Orton Plantation Holdings, LLC

October 31, 2025

Orton Plantation Holdings, LLC ("Orton") respectfully submits these comments on the Section 403 Draft Letter Report and Draft Environmental Impact Statement (collectively, the "Draft EIS" or "DEIS") prepared by the Army Corps of Engineers, Wilmington District (the "Corps") for the Wilmington Harbor Navigation Project, CEQ ID EISX-202-00-K7P-1755163795 (the "Project"). Please add these comments to the administrative record for the Project.

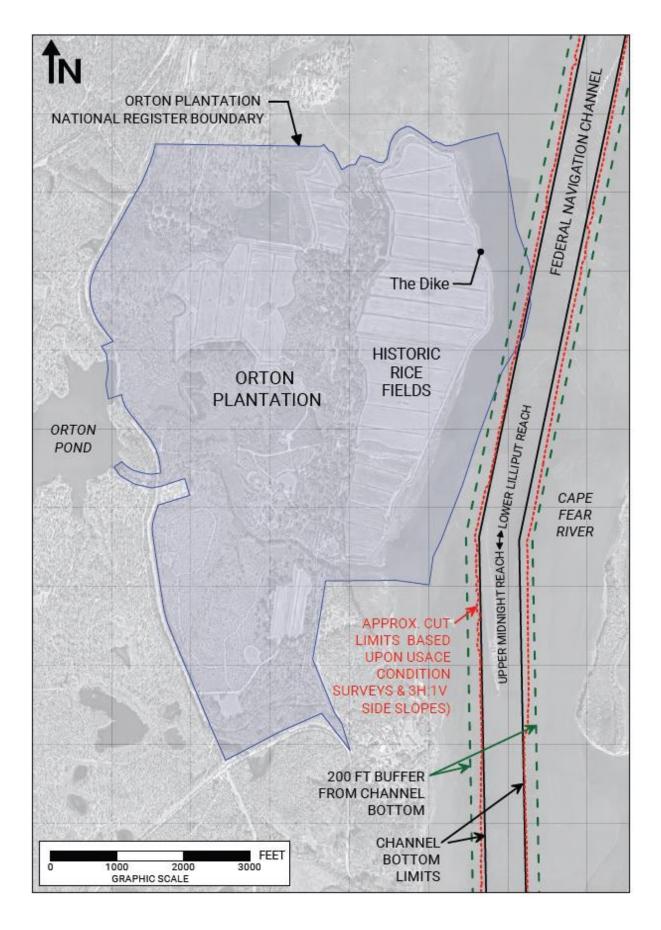
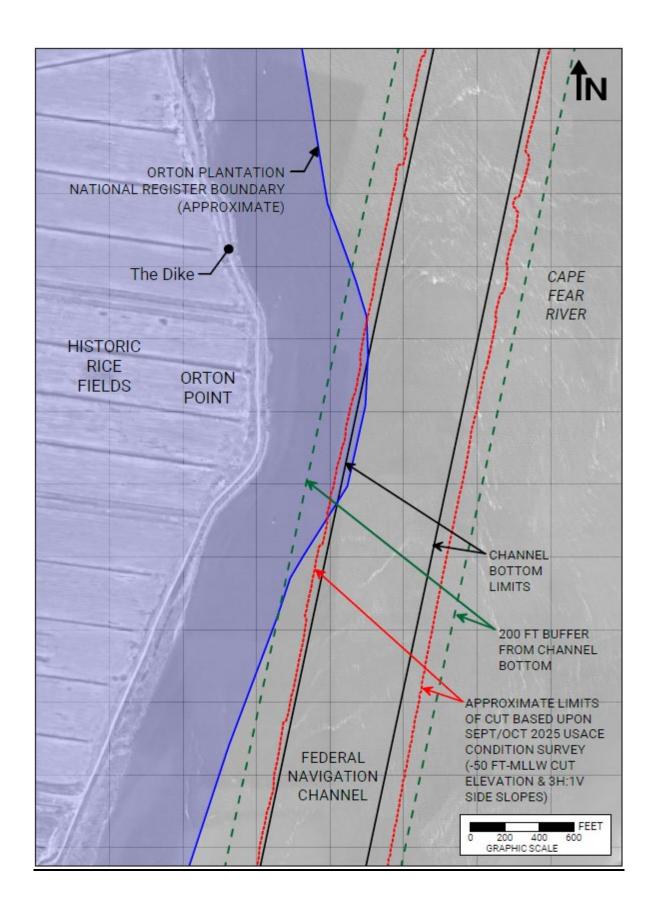
The maps on the following pages show that Project dredging will occur <u>inside</u> the NRHP Boundary for the Property and adjacent to the listed historic dike at the Orton Property.

Readily available geotechnical data demonstrates that the Corps' proposal to dredge in proximity to the historic earthen dike creates an unacceptable risk of global failure of the dike. Failure of the dike will necessarily result in a collapse of the historic rice fields and the freshwater ecological system at Orton.

The dredging design and construction plan present yet another distinct threat of harm to the listed historic resources at the Orton Property. The dredging will occur inside the NRHP Boundary for the Property and impact identified underwater archeological resources. See Pages 3-4 (Figures showing dredging footprint relative to

The Cape Fear River Shipping Channel sits less than 500 feet from Orton Point. *Id.* at 12. The dredging footprint for the Project includes the Channel and a 200-foot lateral buffer to either side of the Channel. DEIS, Appendix E at 27. The dredging footprint overlays and includes the Orton Property NRHP Boundary and the listed underwater archaeological resources protected by that boundary. *See* Pages 3-4 (Figures showing shipping channel and 200-foot lateral dredging boundary overlaying NRHP Boundary).
